STAFF REPORT
COMMUNITY DEVELOPMENT DEPARTMENT

DATE: 3/1/2022
 TO: Mayor & City Council
 FROM: Joseph Dodson, Associate Planner
 208-884-5533
 SUBJECT: FP-2022-0002
 Meridian Movado Village

A final plat consisting of 5 building lots (3 commercial lots and 2 multi-family residential lots) on 6.8 acres of land in the C-G zoning district.

**PLAT SHOWING
MERIDIAN MOVADO VILLAGE SUBDIVISION**
LOCATED IN THE NW1/4 OF THE NE1/4 AND THE NE1/4 OF THE NE1/4 OF SECTION 21,
T. 3 N., R. 1 E., B.M., CITY OF MERIDIAN,
ADA COUNTY, IDAHO
2021

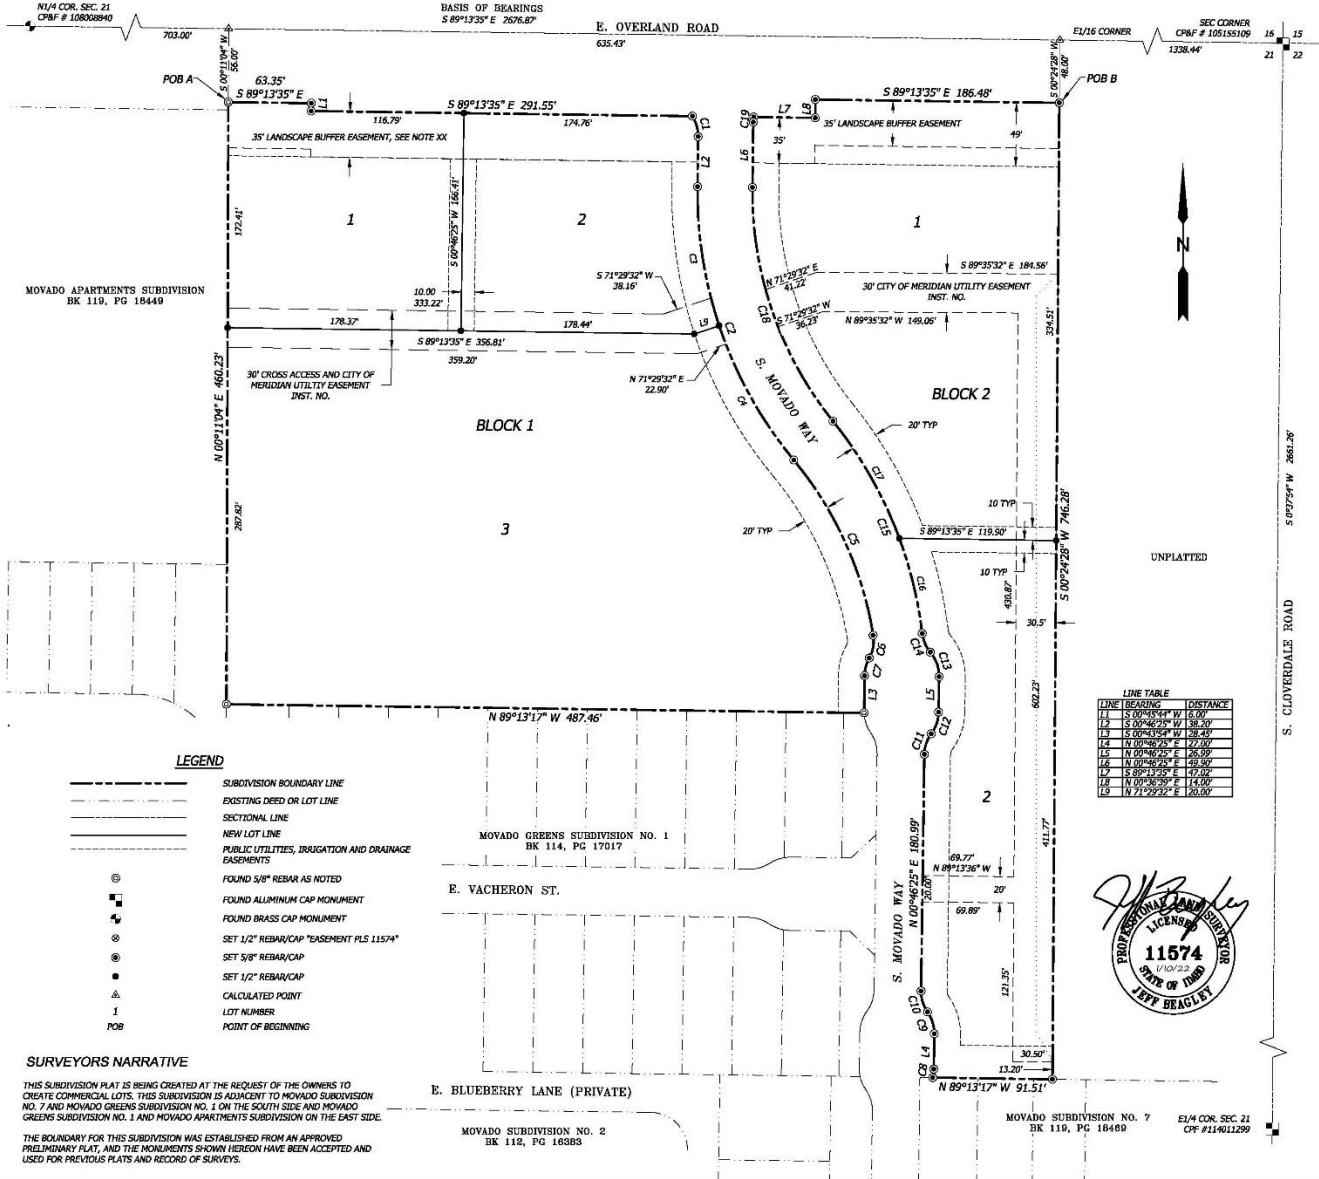
3. Prior to submittal for the City Engineer's signature, have the Certificate of Owners and the accompanying acknowledgement signed and notarized.
4. Prior to signature on the final plat by the City Engineer, the final plat prepared by Sawtooth Land Surveying, LLC (Exhibit B), dated January 10, 2022, shall be revised as follows:

- a. Note #8: Include encumbered lots within this subdivision.
 - b. Note #11: Include the latest DA instrument number for these properties (2021-102395).

- c. Note #13: Include recorded instrument number.
 - d. Add a note addressing any shared parking and/or access between the commercial and multi-family lots. Provide a copy of the recorded shared parking/access agreement with the Planning Division at the time of Certificate of Zoning Compliance application submittal.

- e. Add a note addressing cross-access to the Boise parcel to the east (S1121110200), as required by the Development Agreement. Visually showing the location of this cross-access would also be a benefit.

C. Landscape Plan (dated: January 12, 2022)

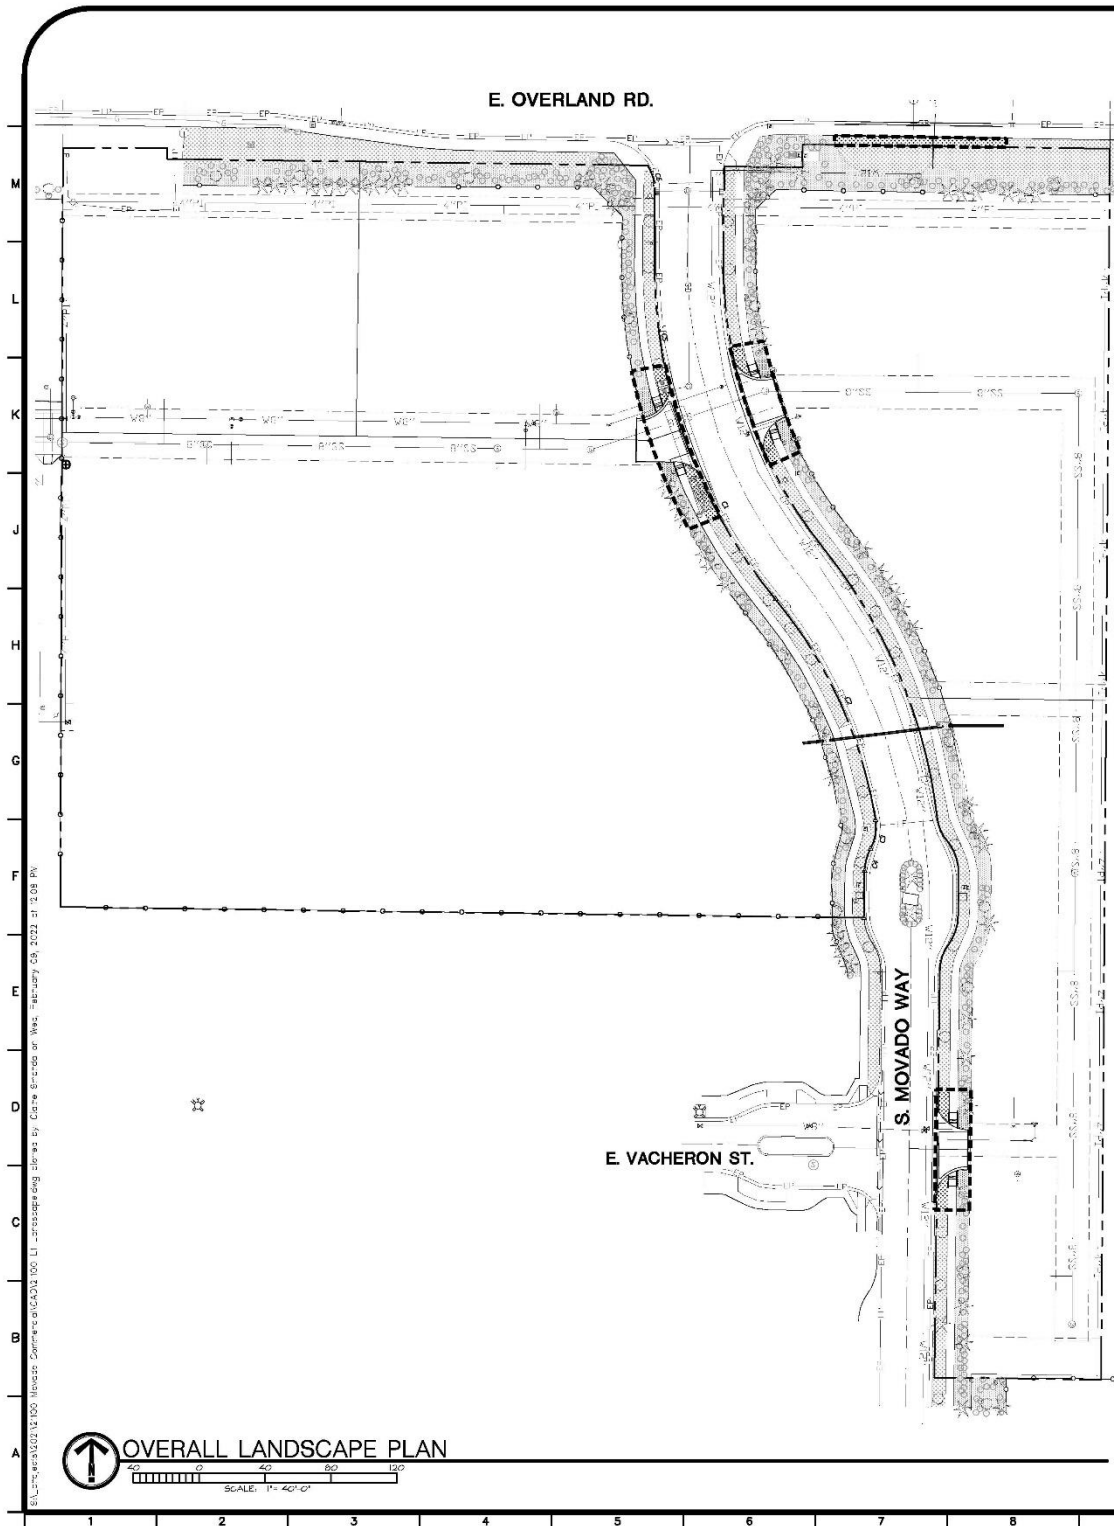
5. The landscape plan prepared by Breckon Land Design (Exhibit C), dated January 12, 2022, is approved as shown. All buffer landscaping has been installed and shall remain protected during construction.
